re: **Geotechnical Excavation Review
Proposed Residential Development
489 & 495 Duvernay Street – Ottawa, Ontario**

file: PG6835-MEMO.01

Kollaard File # 230726-S1

Re: Proposed Single Family Dwelling, 489 Duvernay Drive, Orleans, City of Ottawa, Kollaard Associates File # 230726

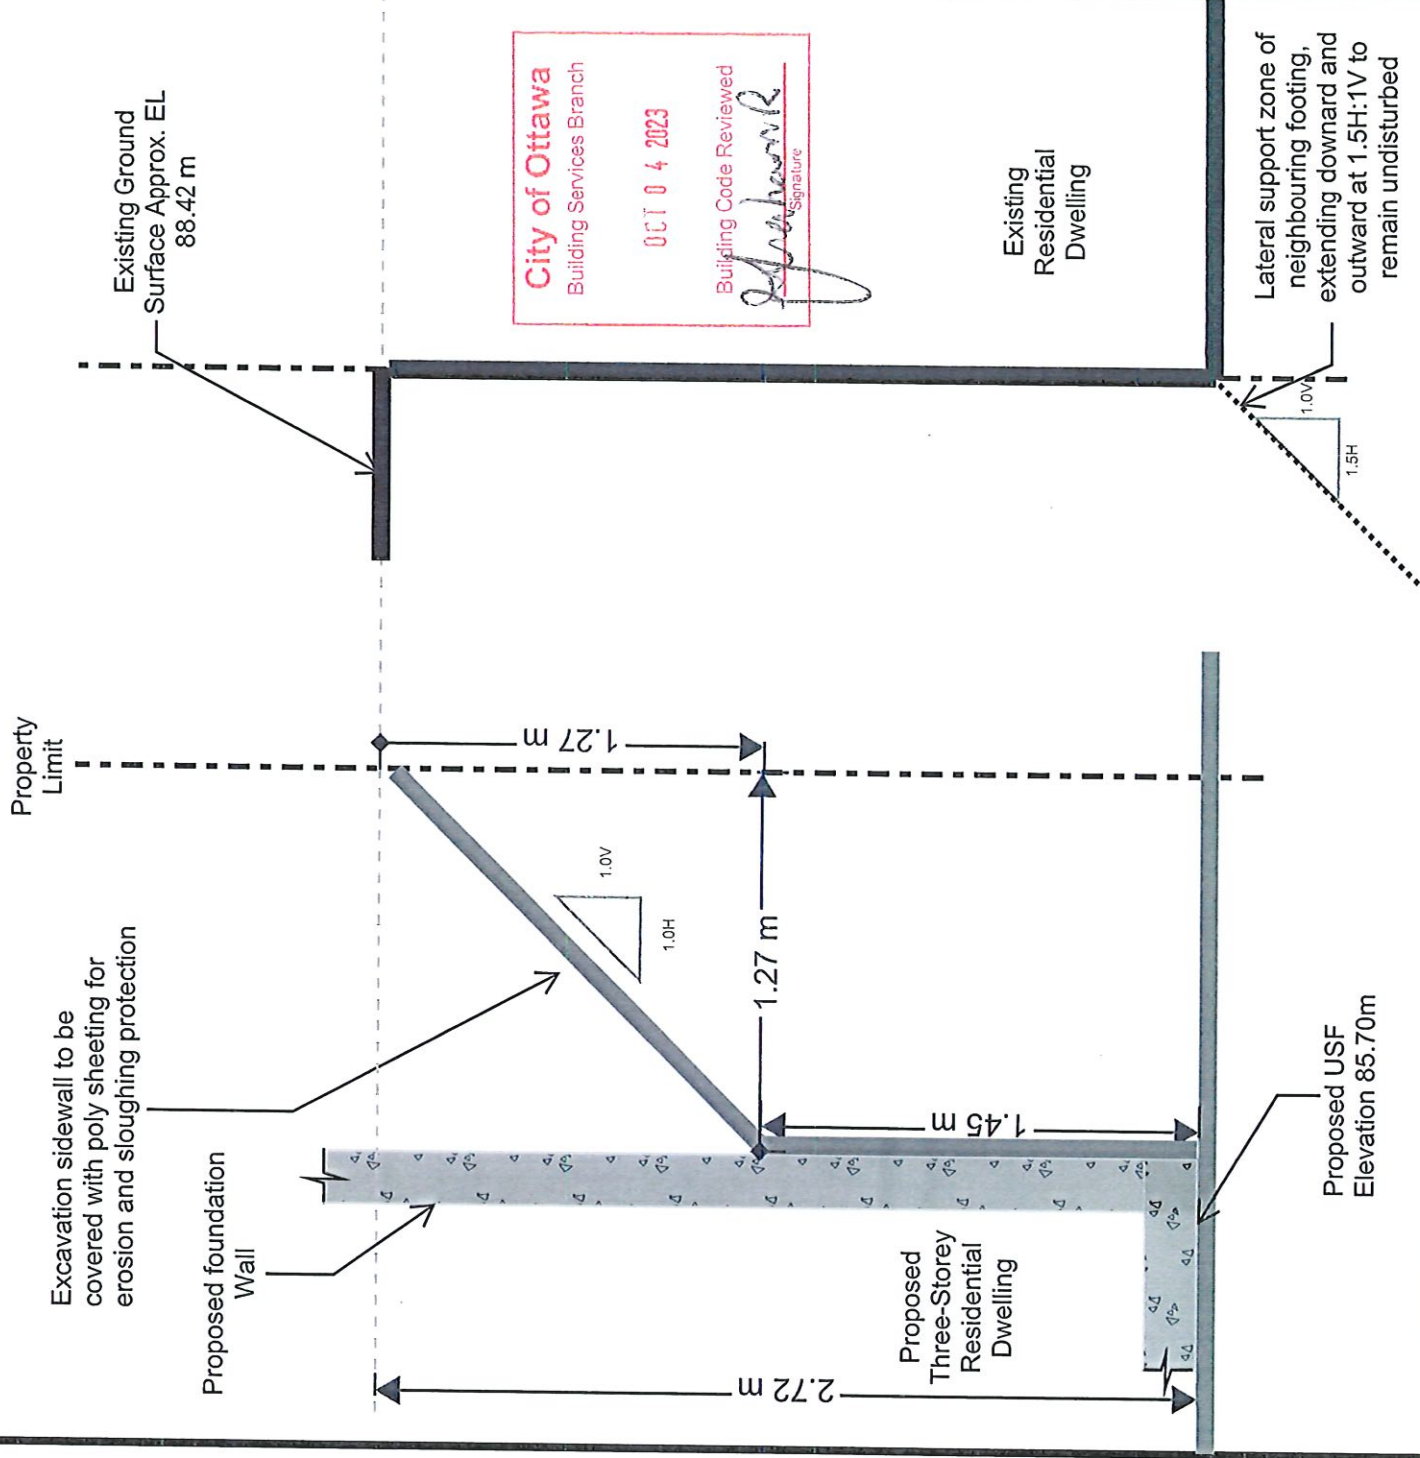
From our review of the available drawings, the proposed development is sufficiently setback from the property lines to allow for the lower 1.5 m of the excavation to be vertical, and then sloped at 1H:1V above this. The limits of the excavation are shown on the attached Figure 2, and the slope cross-section is illustrated on the attached Figure 3 – Section A-A.

- *Where proposing a sloped excavation, plan of excavation including gradient*

See the attached Figure 2 for the plan of excavation, and Figure 3 for the sloping details.
